MIL-V-70579B (AR)
AMENDMENT 2
9 September 1992
SUPERSEDING
AMENDMENT 1
9 September 1991

MILITARY SPECIFICATION

VOLTAGE, CONVERTER: 9360839

Figure 1. Burn-in Temperature Versus Time Diagram

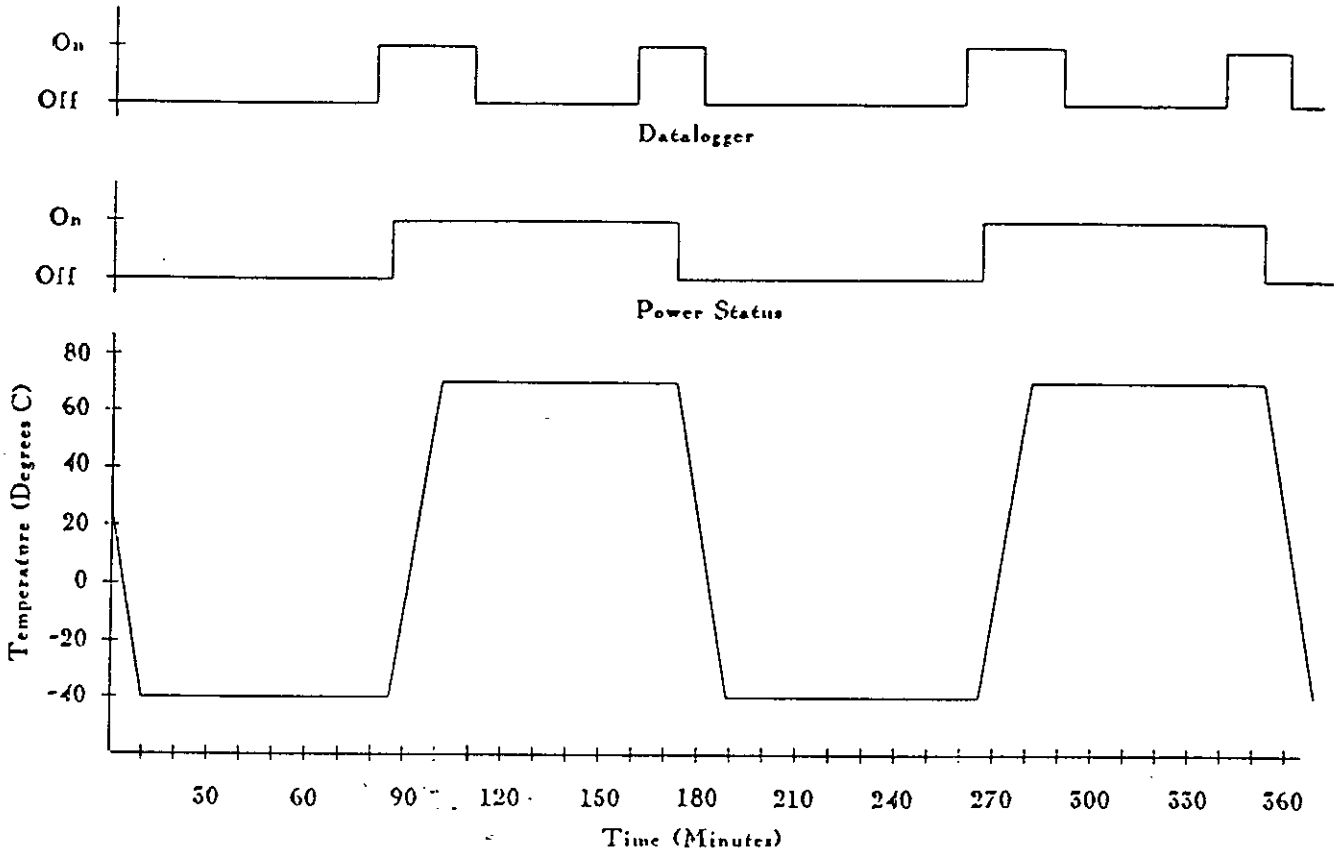
* Figure 1: Delete in its entirety and substitute the following:

Figure 2. Burn-in Test Set-up.

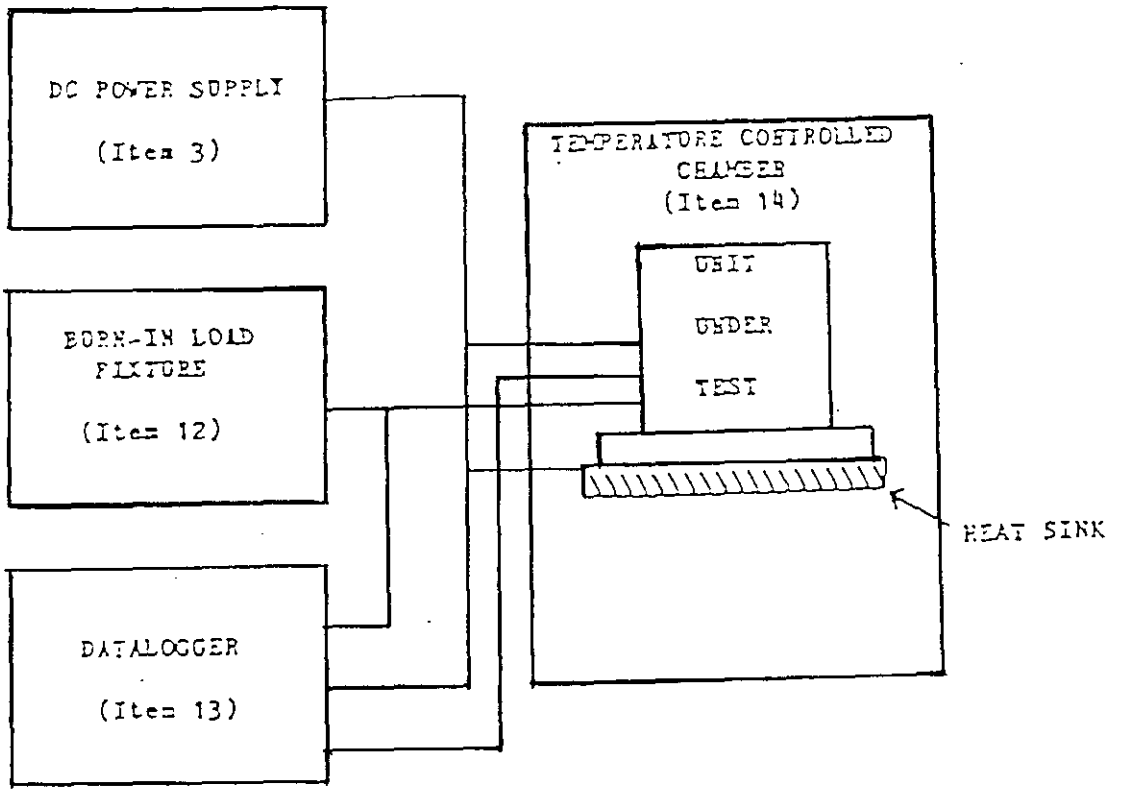
* Figure 2: Delete in its entirety and substitute the following:
